**Summit Reservoir Replacement**  
**Response to Comments**  
**Final Environmental Impact Report**  
*State Clearinghouse #2010072060*

**East Bay Municipal Utility District**

**October 2011**

**Project Existing Site Water Distribution and Drainage Lines  
Figure 2-4**

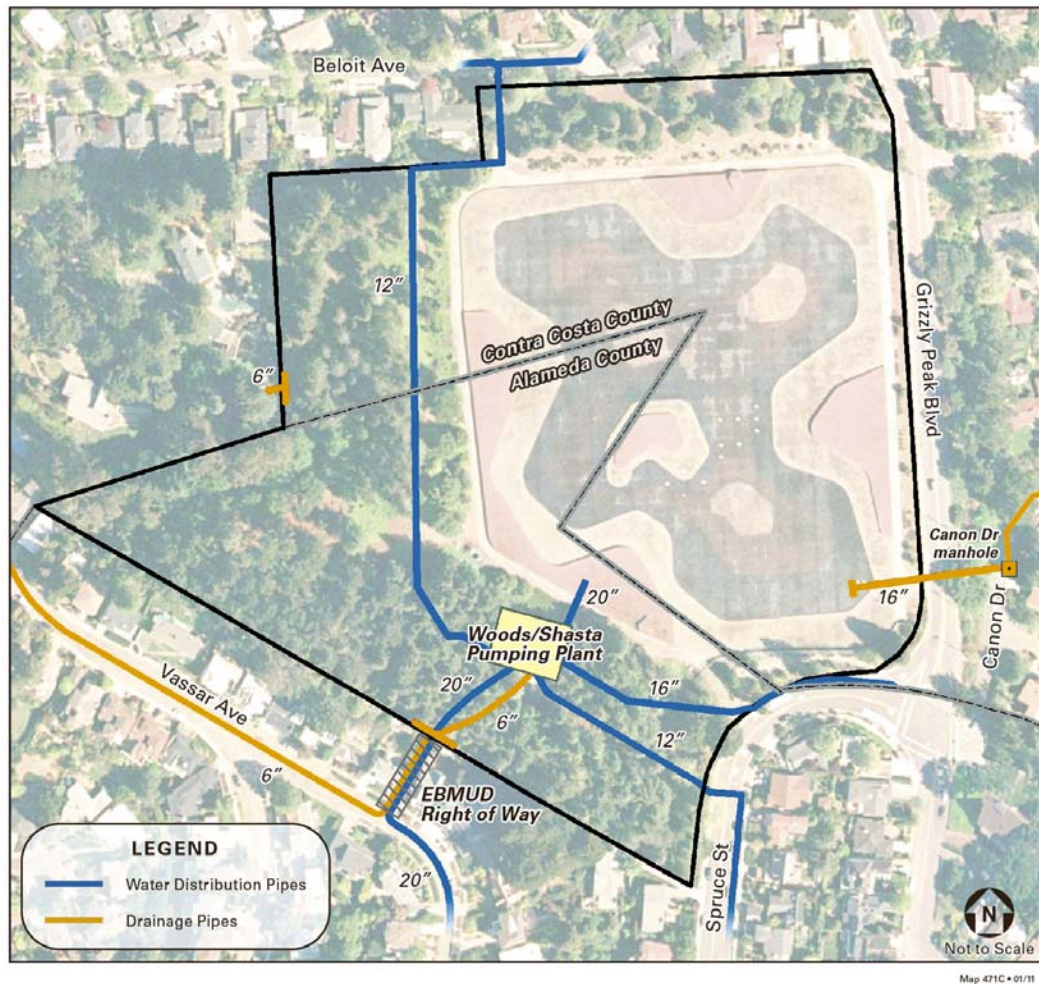
Page 2-14 points out that the I/O pipe from the pumping plant to Beloit Avenue will be increased to 16 inches. This change is not reflected in figure 2-4, page 2-15 which shows the identical I/O pipe as EBMUD drawing 1488 BS16 shows for the existing installation.

KFPD-4 As noted on p. 2-14 of the Draft EIR and consistent with the goals of the Kensington Fire Flow Improvement Study, the Project would increase the diameter of the northern distribution pipeline toward Beloit Avenue from 12 to 16 inches (note: this is not the Summit inlet/outlet [I/O], as identified in the KFPD comment letter). Figure 2-4 shows the existing on-site pipelines and sizes for reference only; the new pipelines have not yet been designed. The title for Figure 2-4 and references to it in the text are revised in Chapter 3, Text Revisions in Response to Draft EIR Comments shown in Section 3.2.2 of the RTC Document to clarify that Figure 2-4 in fact depicts existing facilities.

Other on-site distribution pipelines (~~Figure 2-4~~) from the new Woods and Shasta Pumping Plants to the Arlington and Shasta Pressure Zones would also be replaced with new steel pipes on site. Most of the existing new pipes (~~Figure 2-4~~) would be replaced with pipes of the same diameter as the existing pipes. One distribution pipeline which runs north from the pumping plant toward Beloit Avenue would be replaced with a slightly larger 16-inch diameter pipe, consistent with the goals of the Kensington Fire Flow Improvements Project (EBMUD 1998). Connections to the existing system would be made on site or in the street or sidewalk (public right-of-way) immediately adjacent to the Project site, and most of the existing piping on site would be abandoned in place and filled with concrete, or removed if it lies above the new finished grade.
